# TECHNICAL BULLETIN

Yaesu U.S.A - Amateur Products Division - Technical Support

File No.:	TB-9711	Date:	01-30-97
Model:	FT-1000MP	Serial No. Range:	Problem Units

Problem:	1.8mhz Band spurious problem
----------	------------------------------

Local Unit

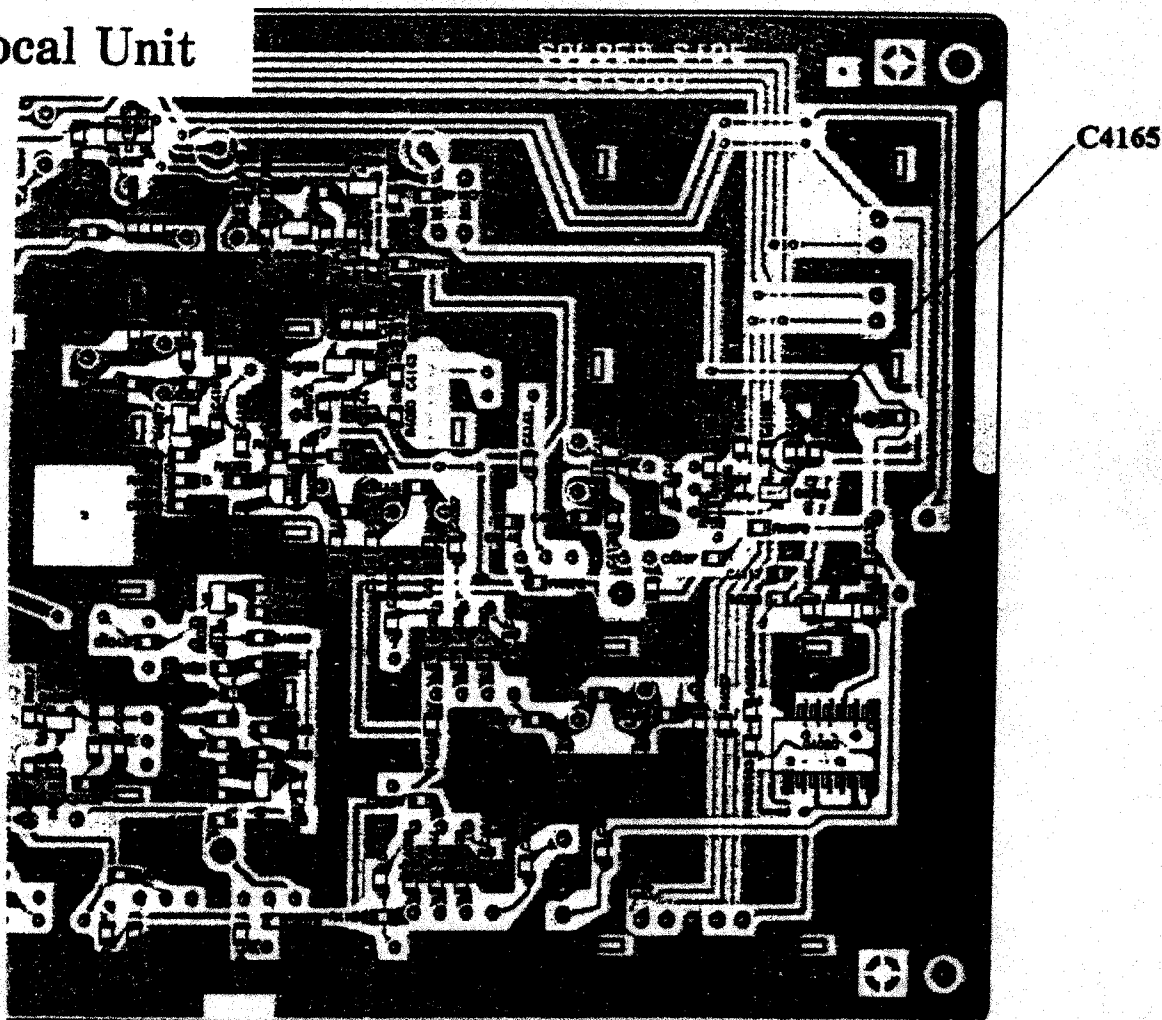
Expected Results of Modification:	Improve cross spurious problem on 1.8MHz
-----------------------------------	--

Component Value Changes: Local Unit		
Part Location No.	From	To
C4165	39pf K22170225 GRM40CH390J50PT	100pf K22170235 GRM40CH101J50PT
